STAFF REPORT

SAN CLEMENTE PLANNING COMMISSION

SUBJECT: Discretionary Sign Permit 13-298, Presidio Plaza Sign Program Amendment, a request to consider modifications to the Master Sign Program of the Presidio Plaza shopping center. The project is located at 401 South El Camino Real within the Neighborhood Commercial (NC2) zoning district.

SIGN ELEVATION
SCALE: 1/8" = 1'-0"

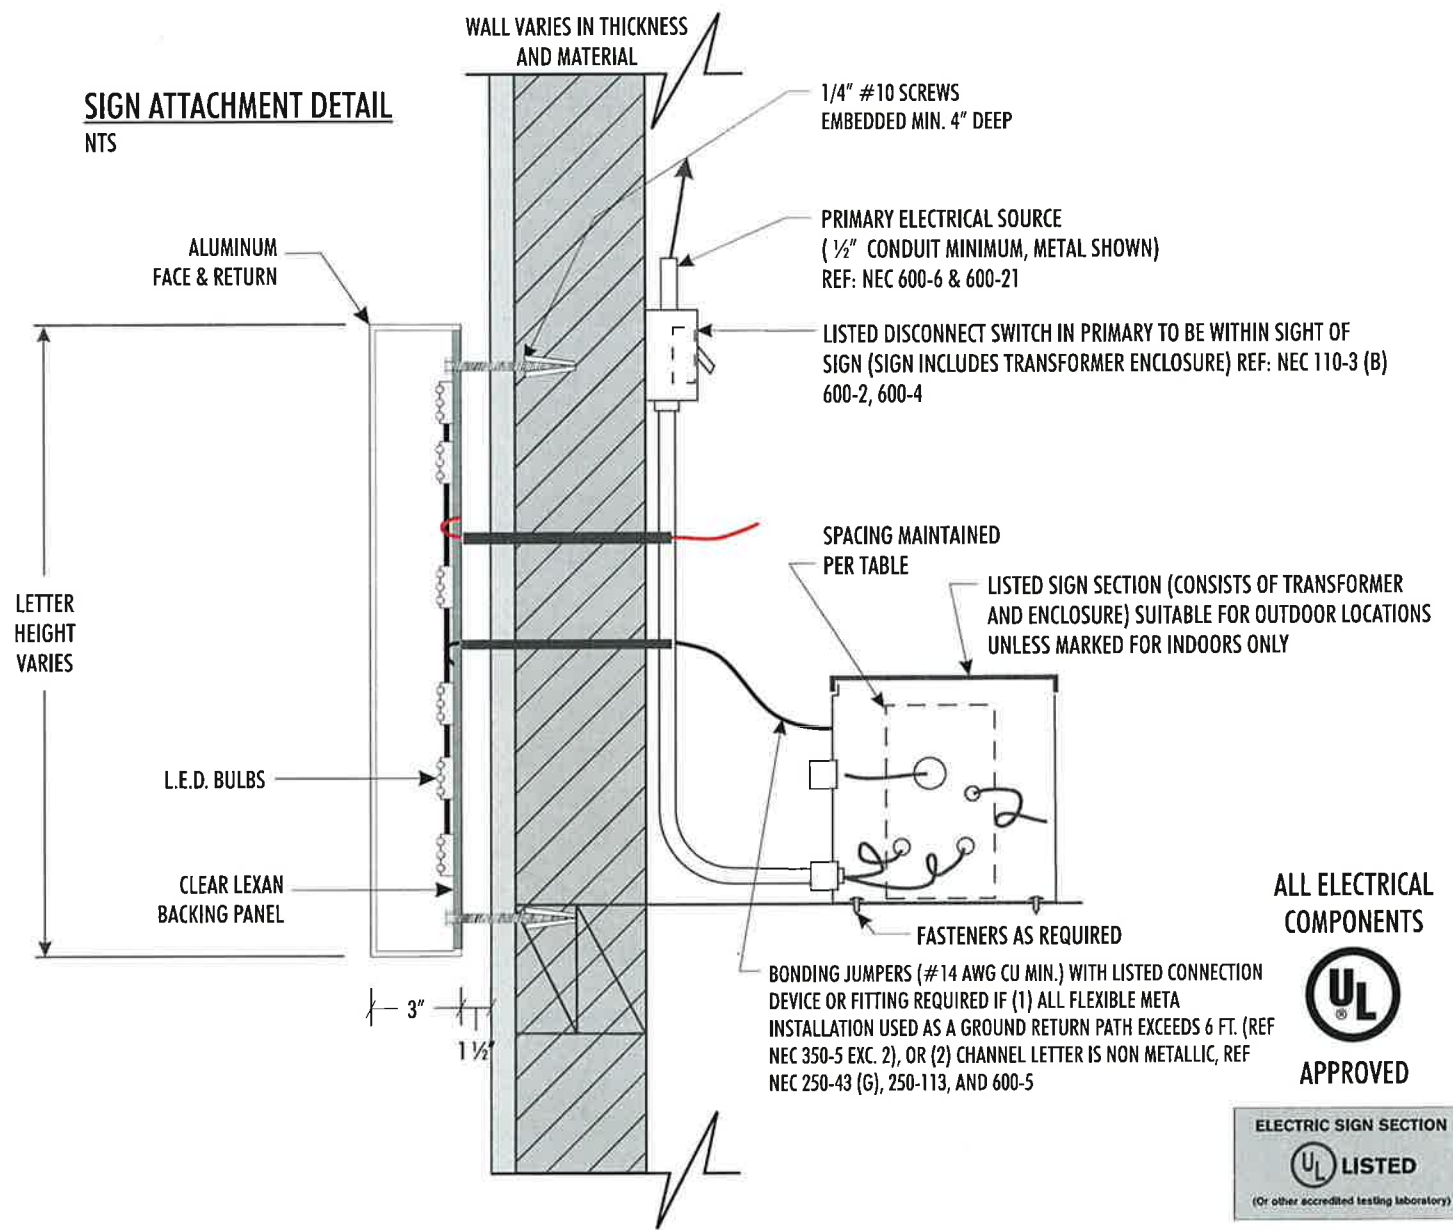
| Master Sign Program Component | DRSC Concerns | Applicant's Response |
|--|--|--|
| Tower Element Sign | Modify lettering with a thinner serif font in a lighter bronze color. | Applicant's proposal complies with recommendation. |

Staff recommends that the applicant modify the color of the center identification signs to be a lighter bronze, and revise the allowable lighting techniques of the Master Sign Program to be consistent with adjacent properties located in the Architectural Overlay. Staff seeks DRSC comments and any additional recommendations.

During Mr. Atamian's staff report summary, John Safar, the applicant, clarified that he included a thinner font for the central tower element as recommended by the DRSC at the previous meeting. He also stated that the duranodic bronze color specified in the plans is a paint application, and that he can make the color a lighter bronze to comply with staff's and DRSC's recommendation regarding all center identification signage.

SIGN DETAIL
SCALE: 1/16" = 1'-0"

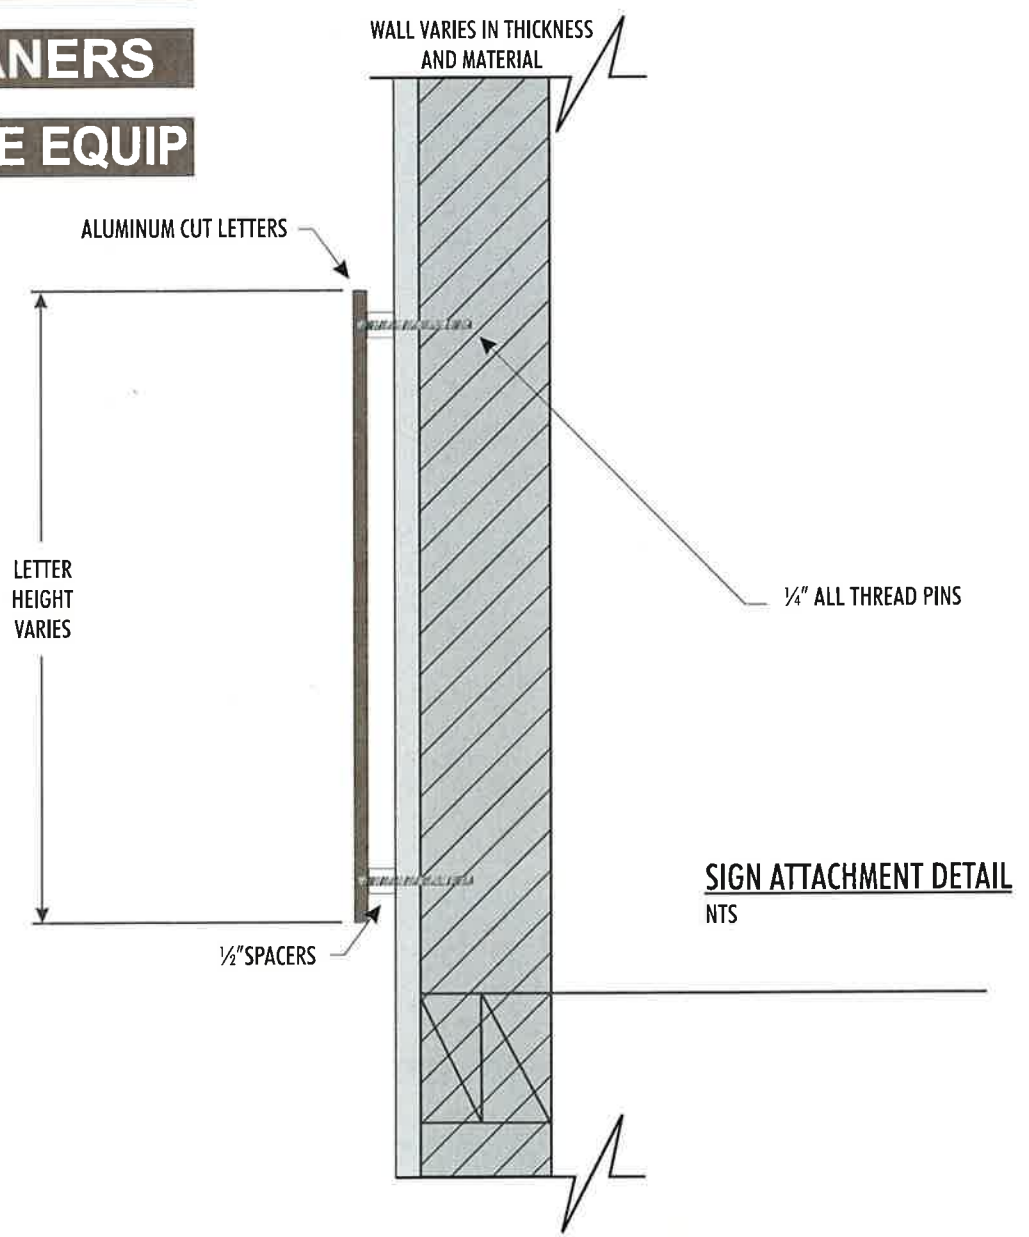
| Master Sign Program Component | DRSC Concerns | Applicant's Response |
|--|--|--|
| Monument Center Identification Signage | Utilize pin-mounted metal letters with color and lettering to match tower element sign. | Applicant's proposal complies with recommendation. |
| Monument Individual Tenant Signage | Include specifications for individual tenant signs that mimic the look of metal and are more compatible with the rest of the center's signage. | Applicant's proposal complies with recommendation. |
| Monument Individual Tenant Signage | Specify all dimensions of tenant plaques to ensure consistency over time. | Applicant's proposal complies with recommendation. |

Due to the prominent location of the monument signs, especially the one at the corner of the property that faces the intersection of Avenida Presidio and South El Camino Real, signage consistent with the design goals of the Architectural Overlay should be used. Staff supports these modifications as proposed, with the only comments being that the font and color should be consistent with the recommendations on the tower element signs.

Subcommittee Member Darden stated that the Master Sign Program is a great improvement over the earlier version reviewed by the DRSC. She said she likes the space between the proposed tenant plaques on the monument signs and asked if the dimensions could be specified on the plans. Mr. Safar stated that he didn't have the exact dimensions, but that he would make that addition.

The applicant proposes to replace the metal flush-mounted center identification signs on the two monuments with pin-mounted aluminum letters. The font and color proposed is the same traditional serif font and duranodic bronze color of the tower element sign. Additionally, the green acrylic tenant plaques are proposed to be replaced with duranodic bronze aluminum plaques that include white vinyl tenant lettering.

REVERSE CHANNEL LETTERS

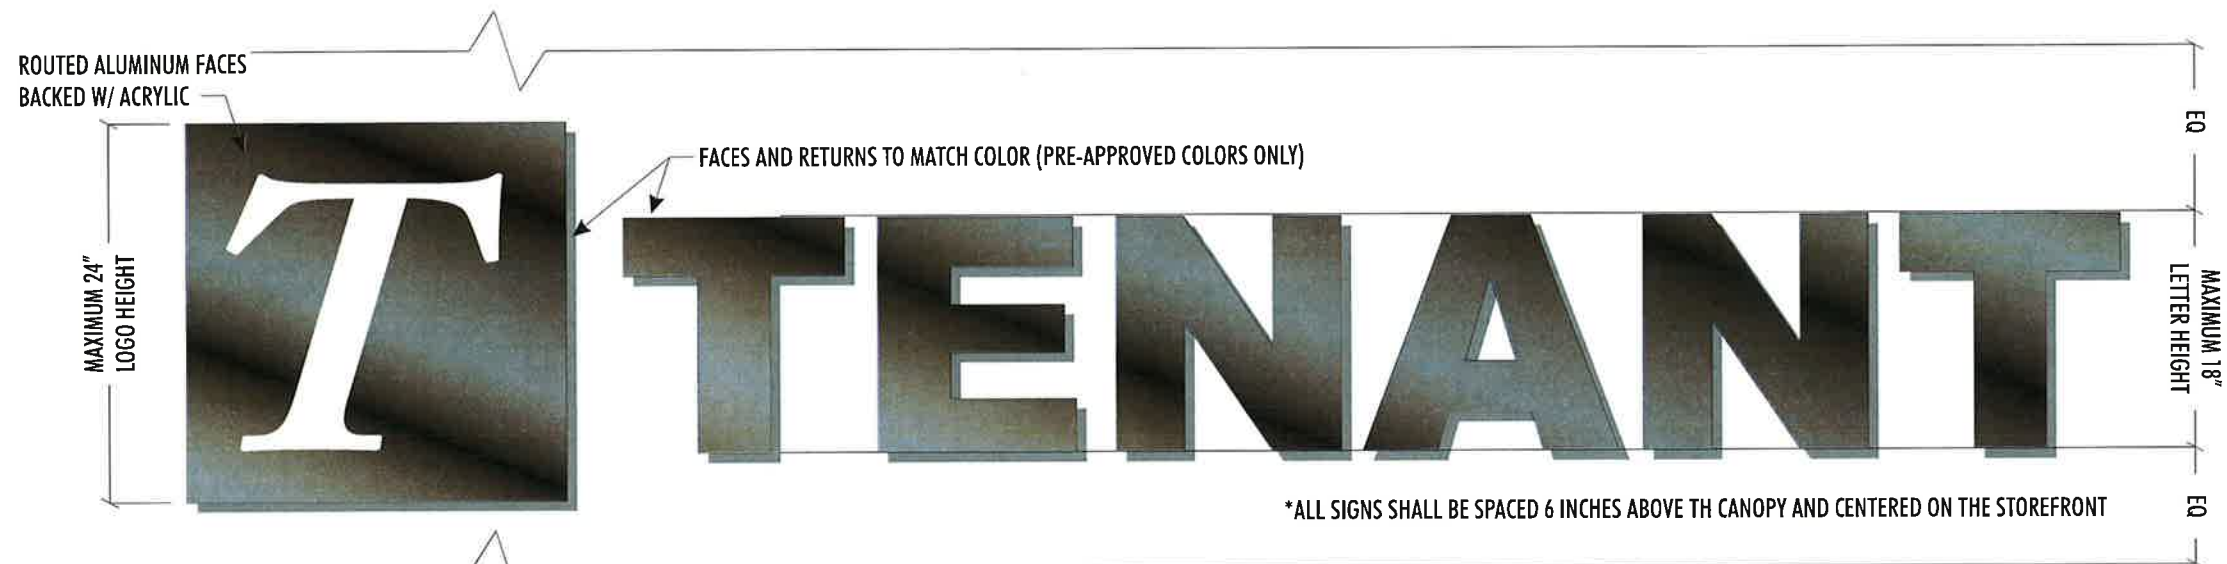
| Master Sign Program Component | DRSC Concerns | Applicant's Response |
|--|--|--|
| Building Tenant Signage | Include tenant signage specifications that allow only external illumination or halo-lit reverse-channel style signage. | Applicant's proposal complies with recommendation. |
| Building Tenant Signage | Maintain a modest color pallet for tenant lettering and corporate logo color options. | Applicant's proposal complies with recommendation. |
| Building Tenant Signage | Include more descriptive language and images regarding acceptable sign styles. | Applicant's proposal complies with recommendation. |

For this reason recommends two modifications to the proposed Master Sign Program. First, staff does not support the use of front-lit channel letters. The only internal lighting allowed should be on reverse channel letter signs. Second, staff recommends that the applicant add external lighting options, such as goose-neck lights and spot lighting, to the allowable lighting techniques listed in the Master Sign Program.

There was discussion regarding the color palette. Mr. Safar stated that there are different color palettes for the face-lit channel letters and the reverse channel letter tenant signs. Mr. Atamian reiterated that staff is recommending that the face-lit channel letter signs be omitted from the Master Sign Program to make the tenant signage more compatible with the adjacent properties. He stated that as the first property located in the General plan update's "Transitional Corridor", there is an opportunity to establish continuity with the Architectural Overlay at this site. Subcommittee member Darden said that she agrees with that recommendation. Mr. Safar said that he could remove the face-lit channel letter signs from the available tenant signage options.

| Master Sign Program Component | Recommendation | Applicant's Response |
|------------------------------------|--|---|
| Building Tenant Signage | Include more descriptive language and images regarding acceptable sign styles. | Type styles, logos, permitted sign types, lighting techniques, and sign materials discussed in greater detail. |
